IMPACT & IMPLEMENTATION REPORT (IIR)

Issue number	IN005/18		
Impacted jurisdiction(s)	South Australia (SA), Queensland (QLD), Victoria (VIC), New South Wales/Australian Capital Territory (NSW/ACT)		
Proponent	Mario Iogha Mark Riley	Company	Origin Energy AGL
Affected gas market(s)	NSW and ACT, Victoria	Consultation process (ordinary or expedited)	Ordinary
Industry consultative forum(s) used	GRCF	Date industry consultative forum(s) consultation concluded	Friday, 15 January 2021
Short description of change(s)	Estimated Consumption after meter removal		
Procedure(s) or documentation impacted	Participant Build Pack 1 (PBP1) – Process Flow Diagrams – V3.6 NSW/ACT PBP5 – Process Flow Diagrams – V3.0 FRC B2B Process Flow Diagrams – V3.6		
Summary of the change(s)	Amend PBP1 – Process Flow Diagrams, PBP5 – Process Flow Diagrams and FRC B2B Process Flow Diagrams to add a new process diagram ‘Meter Not on Premises’ that can be followed across all gas networks for estimating gas consumption due to non-existence of metering assets.

9.1. DIAGRAM 2.8 – METER NOT ON PREMISES

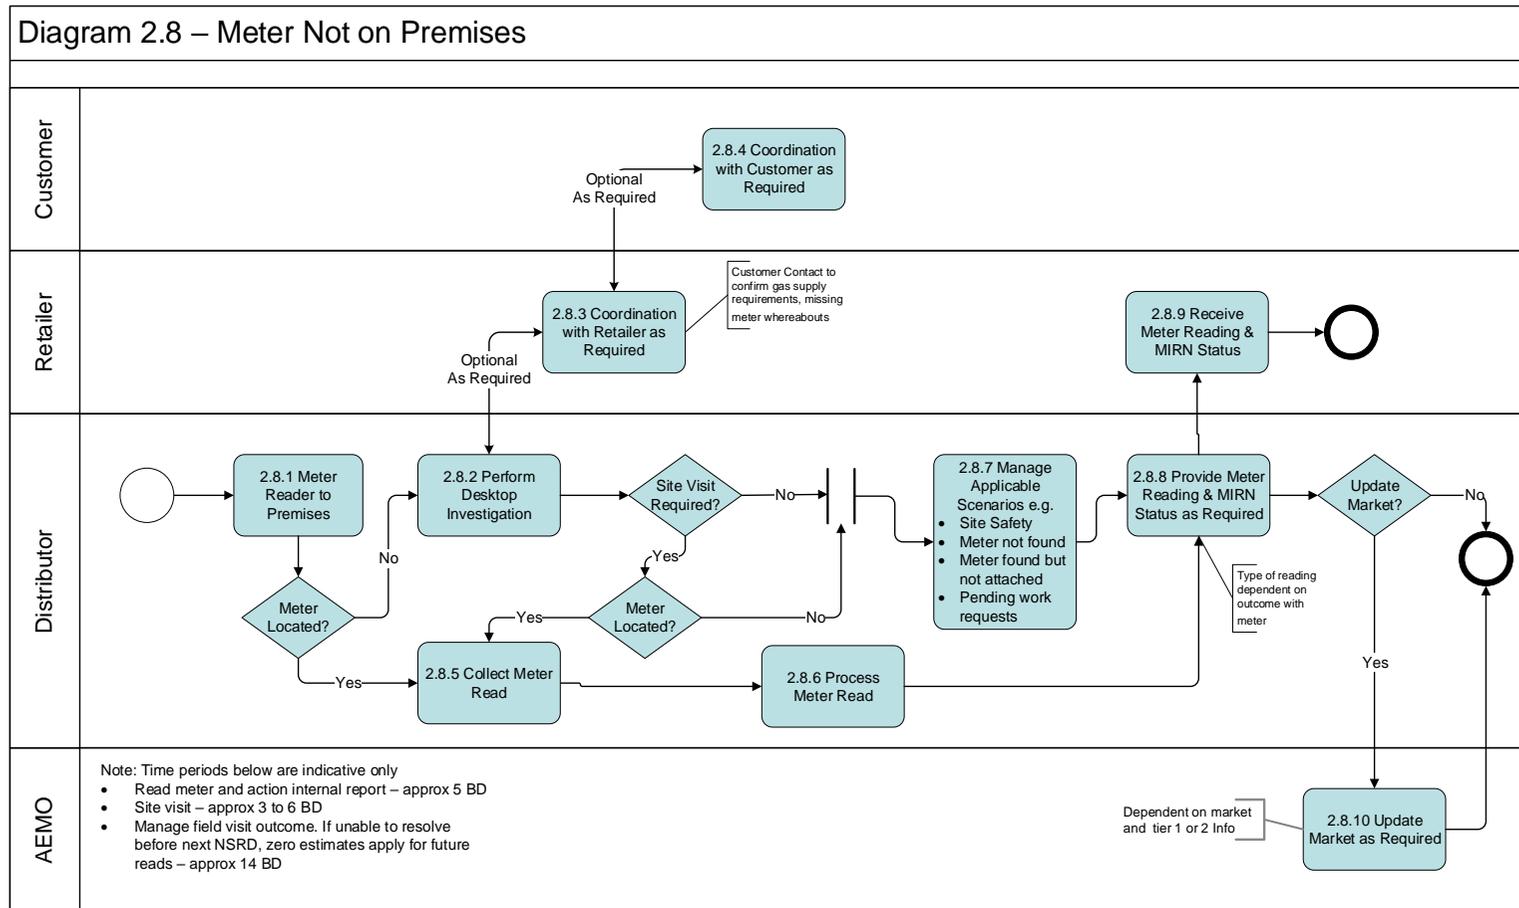
Post PPC numbering has been added and an end point added to step 2.8.9.

9.2. DIAGRAM 2.8 – METER NOT ON PREMISES

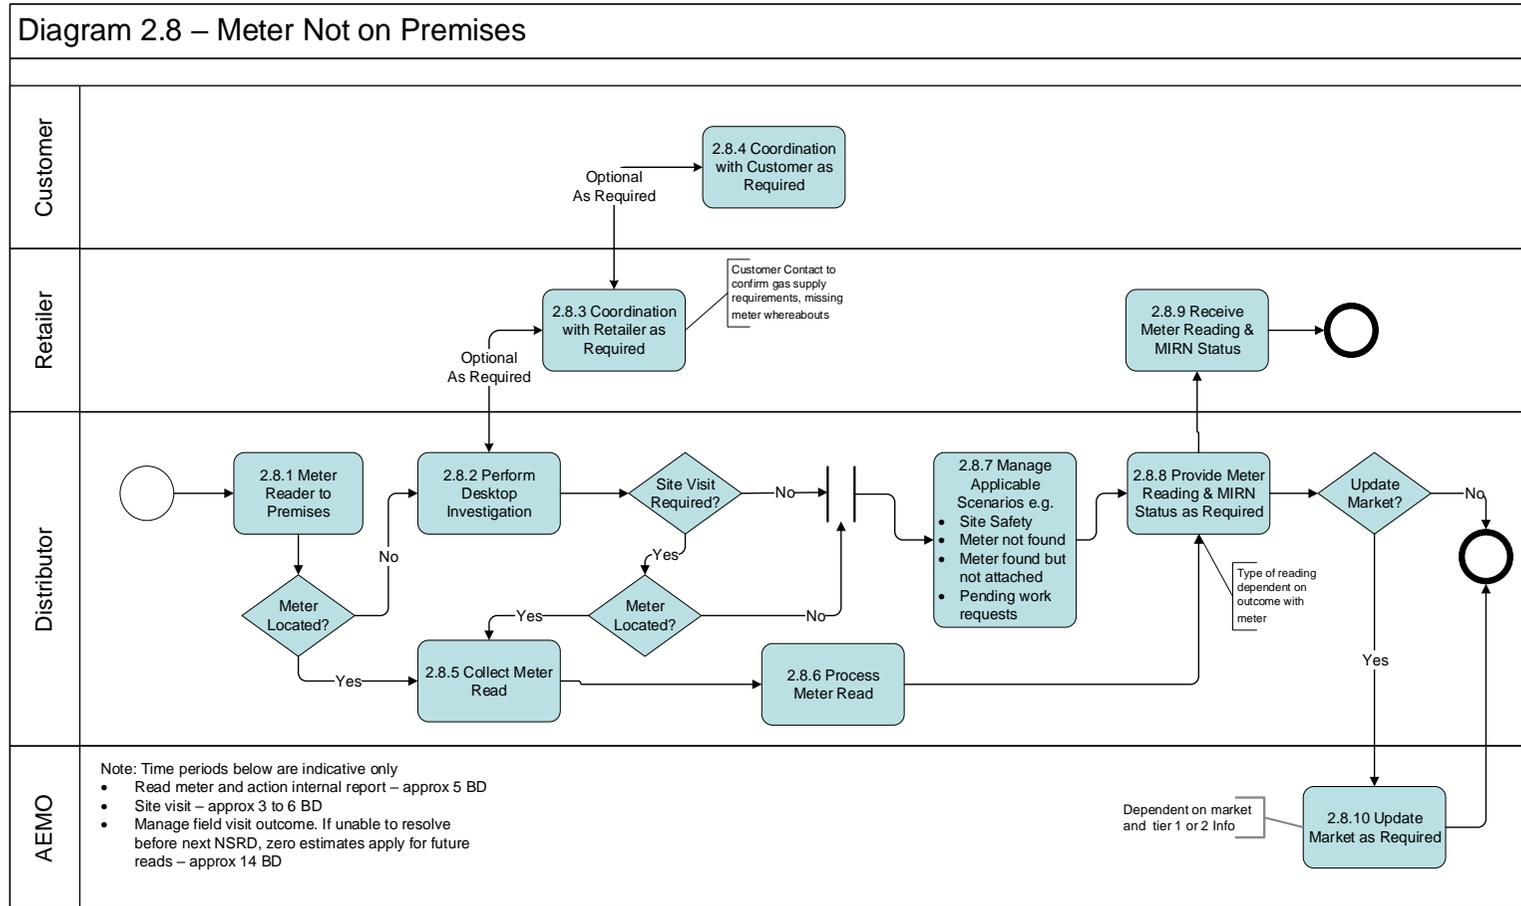
Post PPC numbering has been added and an end point added to step 2.8.9.

The Network Operator may change that estimate if it reasonably considers the revised estimate to be more accurate.	
14	Red/Lum o	Proposed Procedure Change 4.15 Process Flow:MR13A Meter not on premises Diagram 2.8	The third swimlane is labelled 'Distributor'. However, in New South Wales the correct term in the RMP is 'Network Operator'.	Where there is reference to an incorrect term, correct.	AEMO notes that the term 'Distributor' has been used in all process flows and intends to retain it. AEMO has added a new issue (IN004/21) to the Retail Market Change / Issue register to use the correct terminology for the jurisdiction.
15	Red/Lum o	Proposed Procedure Change 4.15 Process Flow:MR13A Meter not on premises Diagram 2.8	The second swimlane is labelled 'Retailer'. However, in New South Wales the correct term in the RMP is 'User'. This also aligns with other process maps contained in FRC B2B Process Flows for the SA and WA Gas Retail Markets.	Where there is reference to an incorrect term, correct.	See AEMO's response for Ref #14.

9.3. Process Flow: MR13A: METER NOT ON PREMISES

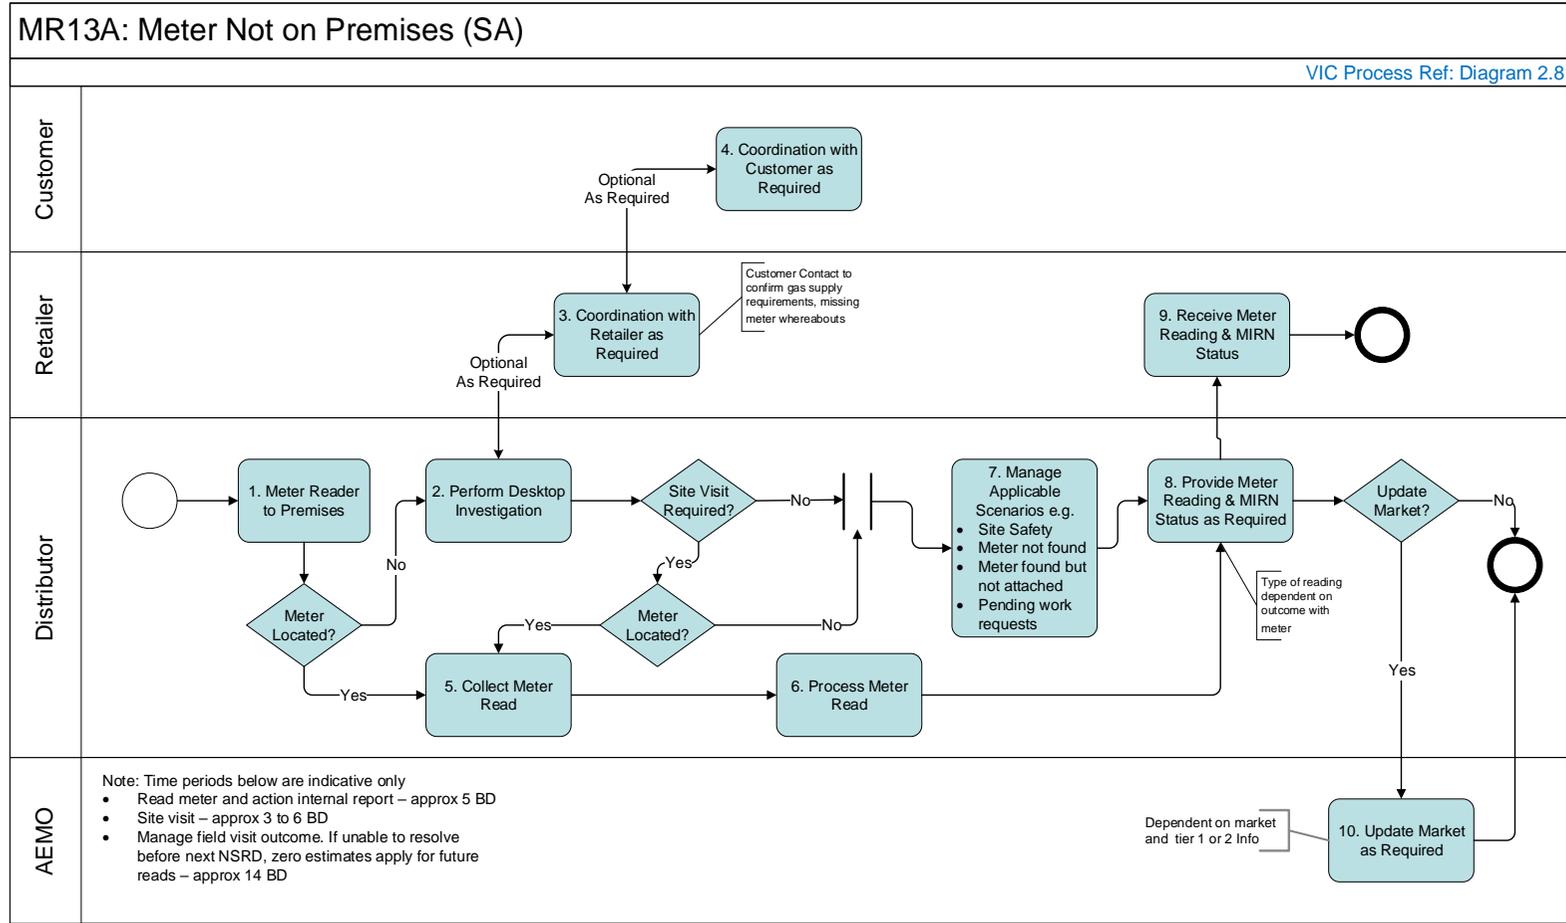
Post PPC numbering has been added and an end point added to step 9.

16	Red/Lum o	Proposed Procedure Change 4.15 Process Flow:MR13A Meter not on premises MR13A	The third swimlane is labelled 'Distributor'. However, in South Australia the correct term in the RMP is 'Network'. This also aligns with other process maps contained in FRC B2B Process Flows for the SA and WA Gas Retail Markets.	Where there is reference to an incorrect term, correct.	See AEMO's response Ref #14

18	Red/Lum o	Proposed Procedure Change 4.15 Process Flow:MR13A Meter not on premises MR13A	The second swimlane is labelled 'Retailer'. However, in South Australia the correct term in the RMP is 'User', 'All Users' or 'Current User'. This also aligns with other process maps contained in FRC B2B Process Flows for the SA and WA Gas Retail Markets	Where there is reference to an incorrect term, correct.	See AEMO's response in ref # 14
----	--------------	---	--	---	---------------------------------
